{All change order of Plans dated 2/29/80 were prepared by Hwy-DB}

{3}-Denotes changes to C.O. ADD 232 - 2/29/80

C.O. ADD. 232

STATE OF HAWAII
DEPARTMENT OF TRANSPORTATION
HIGHWAYS DIVISION
H-1 VIADUCT (E.B. & W.B.), RAMP A, RAMP F & RAMP G
LONGITUDINAL SECTION
SH. 2 OF 2
KEEHI INTERCHANGE
F.A.I. PROJ. NO. I-HI-1 (131):17
SCALE: AS SHOWN DATE: AUG. 31, '77
SHEET NO. S-5 OF 5-94 SHEETS

SECTION F
N.T.S.
S-24 S-23
Looking Up Station

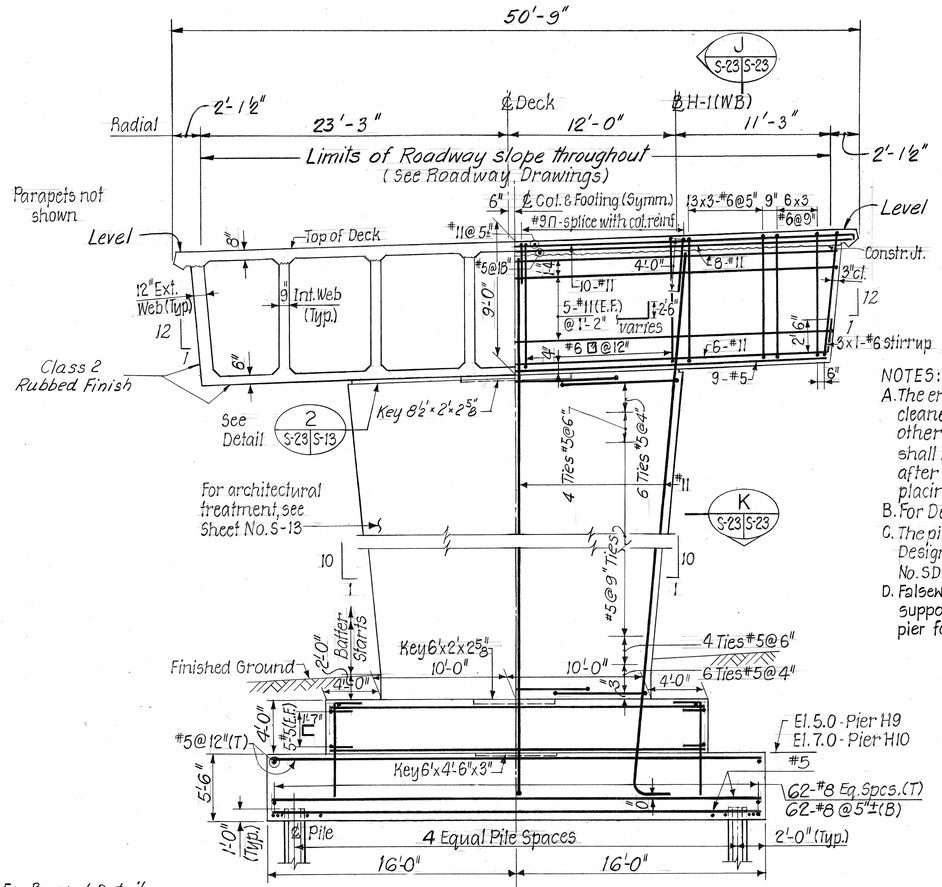
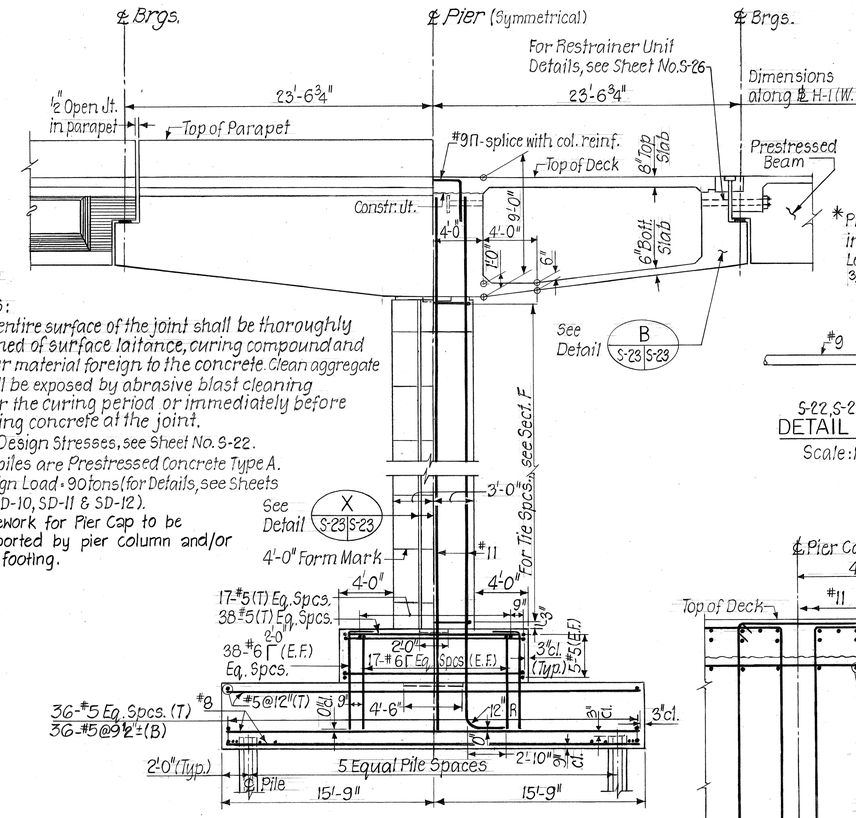
DATE	REVISIONS
7/21/78	Revised ftg. size & ftg. reinforcements in Sections F S-24 S-23 & G S-24 S-23

PLAN
Scale: 3/16" = 1'-0"

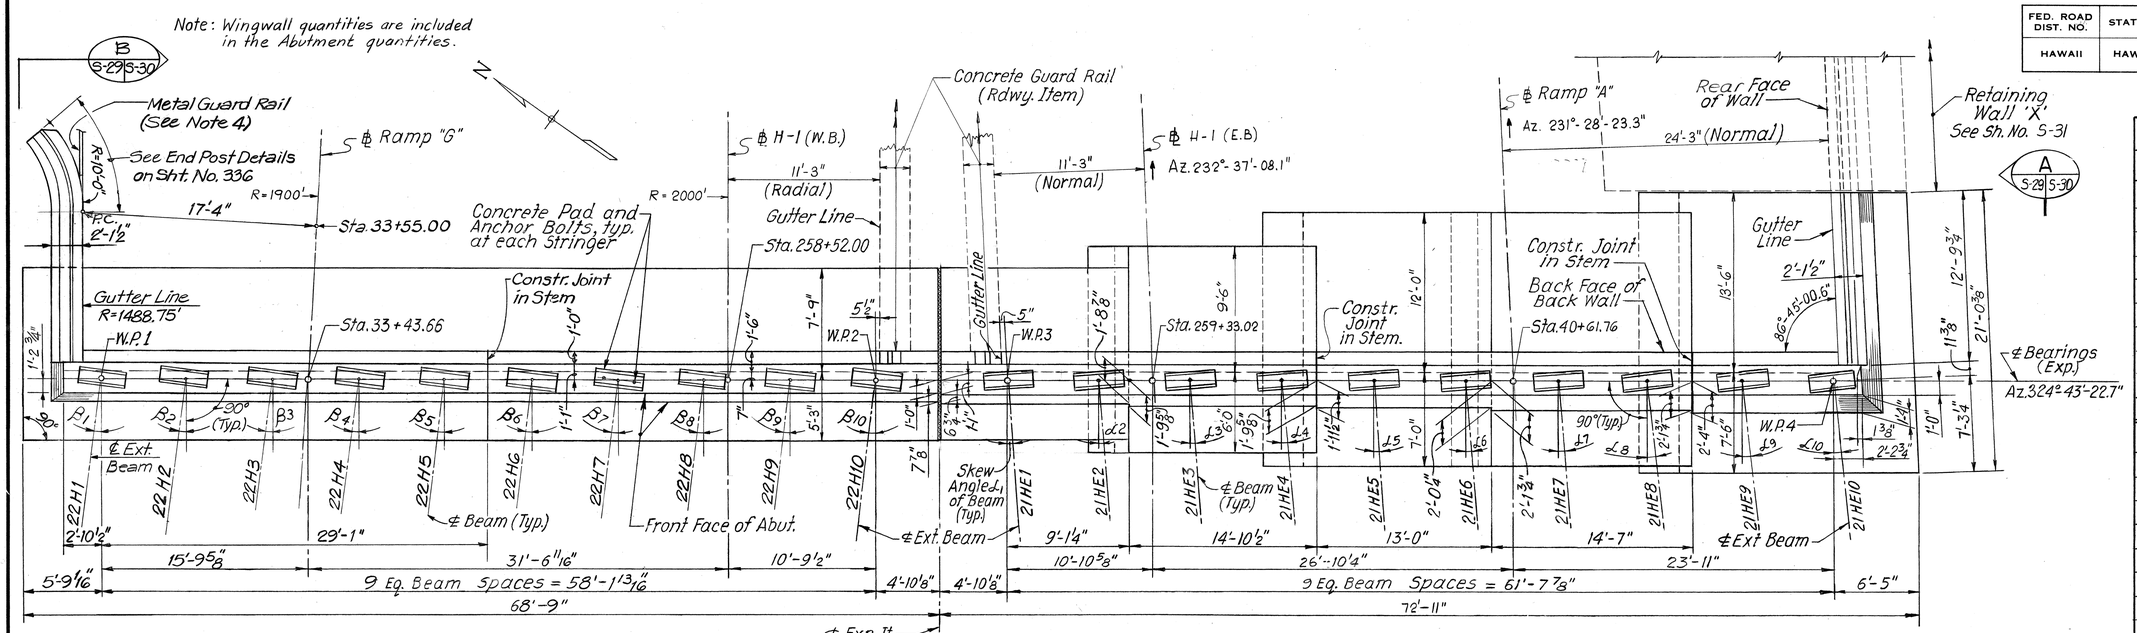
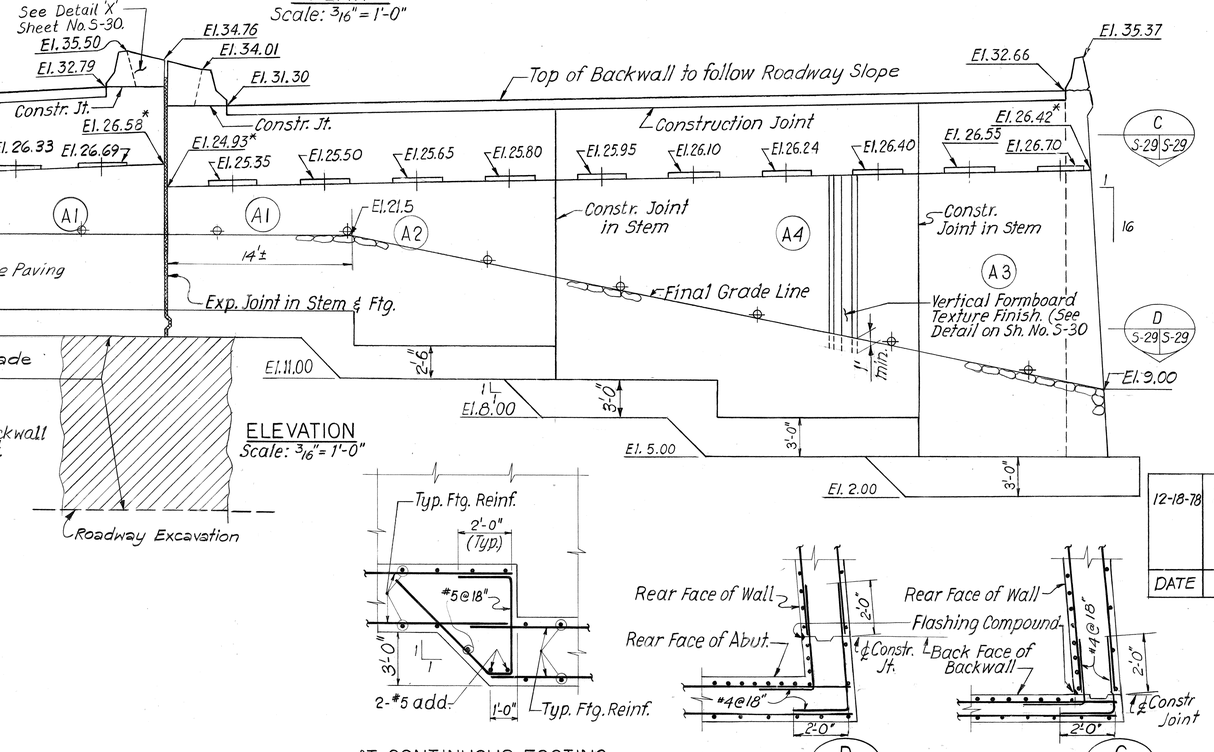
DATE	REVISIONS
12-18-78	Added Beam 22H10. Revised dimensions & Beam Pad Elev. on H-1(WB) Abut. Plan & Elevation. Revised Table of Skew Angles of Stringers 22H1 thru 22H10. Revised Beam Spacing on H-1(EB) Abut. Plan
